County Response to Comments to Snyder Geologic letter dated January 13, 2014

Jacumba Community Services District

Tierra Del Sol Groundwater Resource Investigation

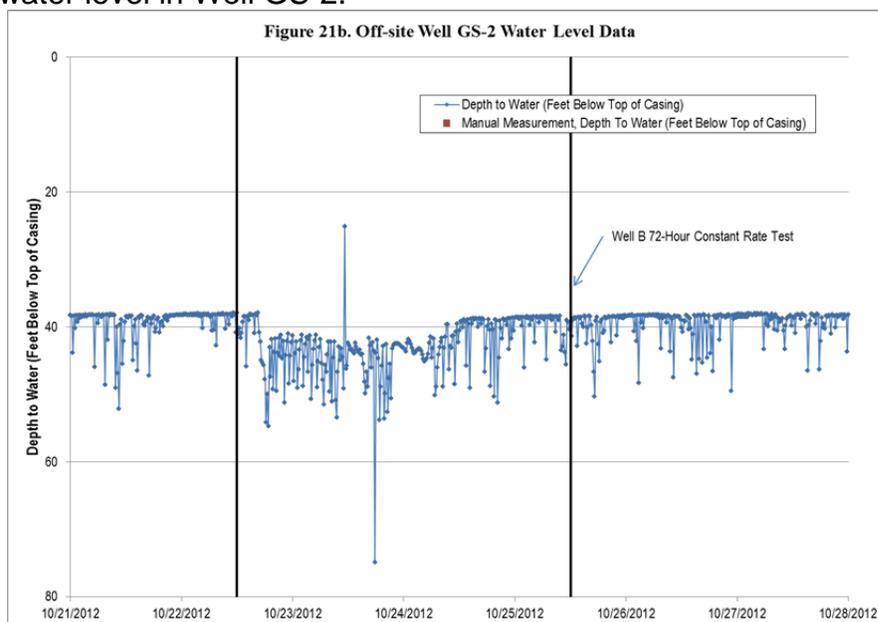
Comment 16: Although Dudek claims drawdown was not observed in any off-site wells during testing of Well B, drawdown at GS-2 is apparent in the graph (Figure 21) during the test, but the supporting datalogger readings are not provided in the report, only the 3 manual measurements. Data from the data loggers for GS-2 should be provided.

Response 16: Dudek claims that drawdown does not appear to result in any of the off-site wells as a result of pumping Well B. It appears Well GS-2 was being pumped by the homeowner during the 72-hour constant rate test (see figure 21 of TDS GRIR). Well GS-2 pump cycles on and off on a pressure switch in order to sustain pressure in an adjacent pressure tank. The water level recovered in Well GS-2 prior to the Well B 72-hour test ending suggests that this is water level recovery from pumping Well GS-2 (see figure 21b below, which is figure 21 at large scale) and not the result of pumping Well B. Well GS-2 is reported to be 366 feet deep with a pump depth of 320 feet and a maximum reported production capacity of 65 gpm. Additionally, adjacent off-site wells were pumping during the Well B 72 hour constant rate test including GR-1 (see Figure 19 in TDS GRIR) and other unmonitored residential wells, which likely influence the water level in Well GS-2.
